Docket Item #1 & #2
BAR CASE # 2016-00344 &
2016-00345

ISSUE: Permit to Demolish and Certificate of Appropriateness for a New Addition and Alterations

LOCATION: 703 South Lee Street

STAFF RECOMMENDATION December 21, 2016

*Figure 1, Left: view of north elevation of 703 S. Lee Street, taken from South Lee Street looking westward.
Figure 2, Right: view of north elevation of 703 S. Lee Street, taken from the south side of Franklin Street, looking southward.*

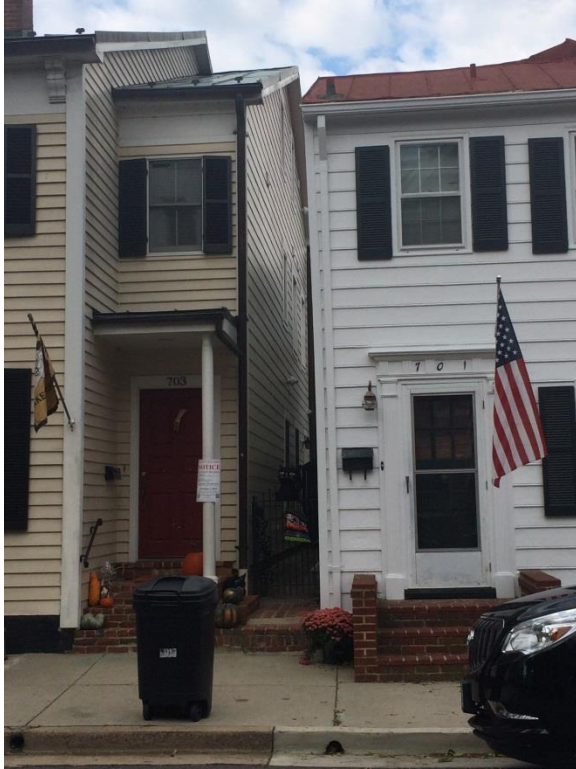
The remainder of the proposed window revisions on the north elevation is unchanged from before and, as staff noted previously, is minimally visible looking down the horse alley from South Lee Street (see Figure #1, below). Although the intersection of the rake boards on the west elevation where the dormer meets the shed roof is a bit awkward, staff reminds the BAR that this elevation is not visible from a public way and is not subject to BAR review. This elevation is provided simply to explain the overall dormer form.

All of the north elevation of the dwelling is visible, obliquely, from South Lee Street through the alley that separates 703 and 701, though a majority of the north elevation is clearly visible from several vantage points along Franklin Street. (Figures 1 and 2) The third floor of the proposed rear expansion, especially the proposed third-floor dormer windows on the north elevation, will be visible from Franklin Street.

Figure 3: 703 S. Lee Street as seen from the north side of Franklin Street, looking southward. The crude Photoshop insert by staff of the proposed addition is not to scale, but is illustrative of the fact that the proposed dormers and extended roofline will be visible from the public right-of-way.

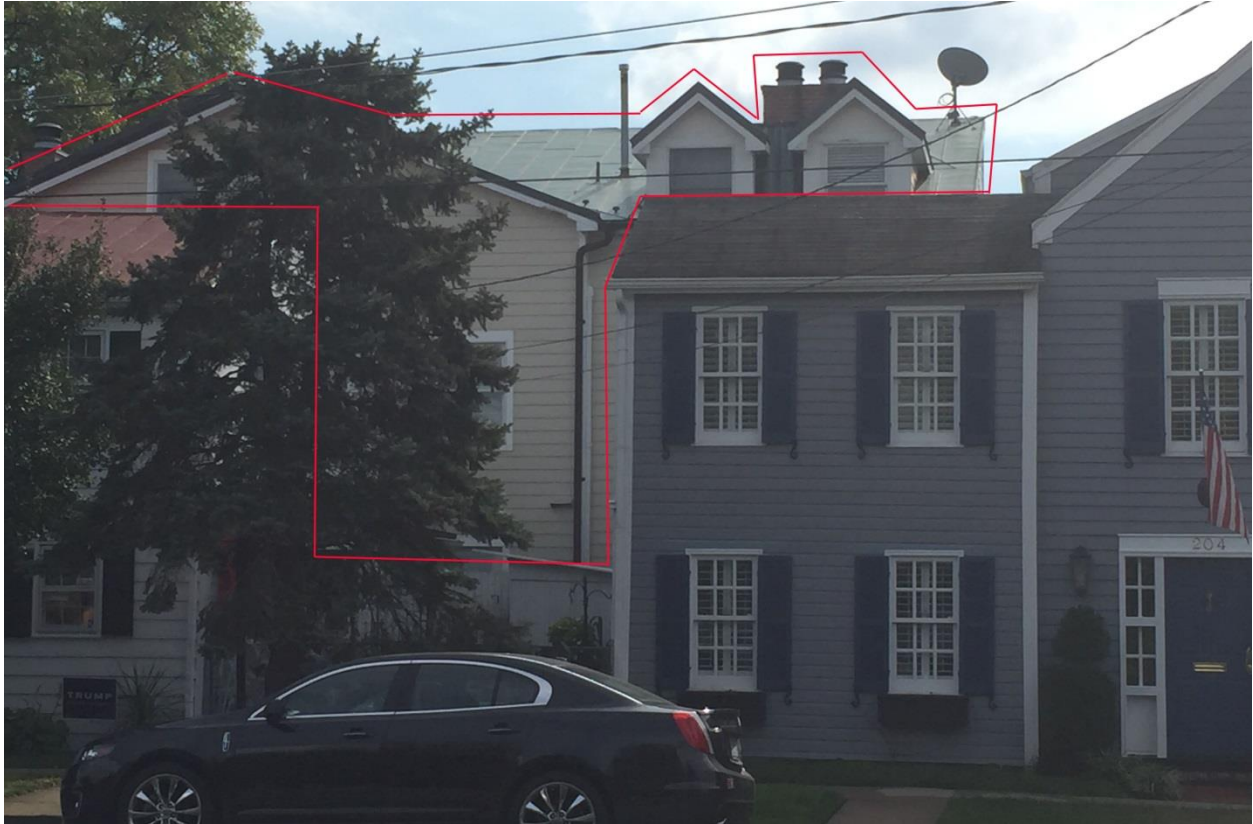
*Figure 3: 703 S. Lee Street as seen from the north side of Franklin Street, looking southward.
The red outline roughly marks visibility from the right-of-way.*

Staff is concerned that the addition of a new even larger dormer beside the two existing gable roof dormer windows on the north elevation, which are themselves already too large, would be out of scale with its context and loom over the houses to the north. (Figure 3) The proposal to have a total of three individual gable dormers—with differing fenestration patterns—in this location is also awkward, while their size and saw-tooth roof form draws undue attention to these architectural elements. The dormers are being requested to create additional habitable floor space below the steep pitch of the shed roof of the ell but they should not be overwhelming design elements and should be appropriately scaled to fit within the context of the historic buildings of merit nearby. Staff recommends deferral to restudy both the existing and the proposed dormers, perhaps considering two smaller shed dormers or a single continuous shed dormer there instead, and that the ceiling height within the dormer be limited to the top of the existing windows on the north side of the room (approximately 6'8" tall?) to minimize the height and mass of the dormers on the exterior.

SHEET NUMBER
A-6

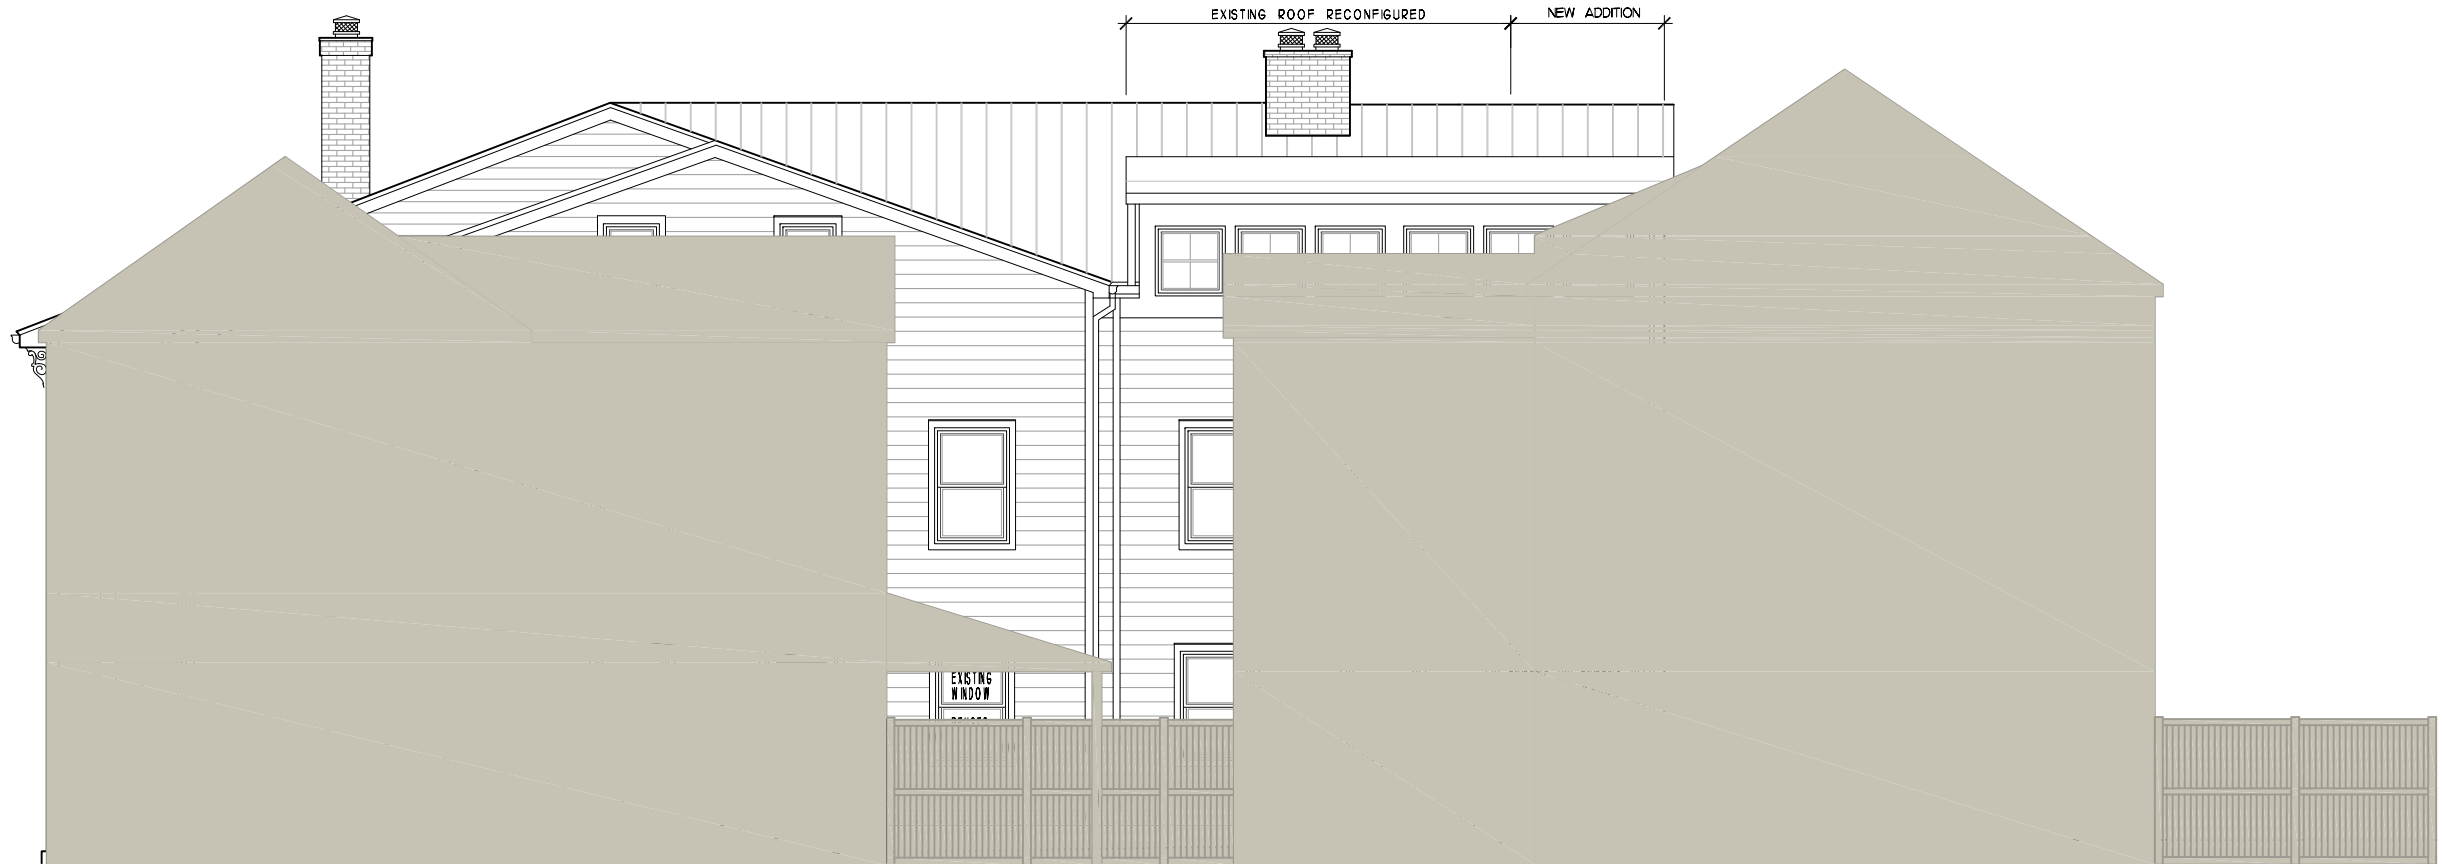
At the November 2, 2016 hearing the BAR noted that the roof forms shown on the proposed north and west wall elevations appeared to be in conflict and that this confusion potentially affected the dormer design. They also asked that the dormers have a better design relationship to the windows on the north wall below and that the rhythm of the dormers be more studied, so that all three have a formal composition and could appear to have been constructed at the same time.

The applicant has resubmitted a greatly simplified, 20th-century shed dormer form on the 1993 ell. While it is significantly wider and contains more windows than before, the front gable roofs of the previous dormers are eliminated and no longer visually project above the ridge to create a saw-tooth skyline when seen by a pedestrian from Franklin Street. From the exterior, the dormers on the rear ell are no longer trying to be a primary design feature, do not need to align with windows on the wall below or the chimney above and no longer compete for attention with the facades of other houses on Franklin Street. As can be seen on the applicant's revised context drawing on revision Sheet A-7, dated 11/28/16, the adjacent houses block the view of the majority of the north elevation of the subject house, so the proposed dormer is now a minor architectural element that visually recedes into the roof. As the Design Guidelines recommend, the proposed dormer becomes part of "contextual background buildings which allow historic structures to maintain the primary visual importance." (Residential Additions – Page 2) For the applicant, the simple, continuous shed dormer with a simpler roof form provides more interior plan flexibility, more daylight, and greater headroom.

Staff supports the revised dormer design and finds it is a substantial improvement over the appearance of both the existing dormers and the previous dormer proposal. The previous staff report is repeated below in its entirety for reference, with the portions no longer applicable struck thru. The revised application drawings are attached.
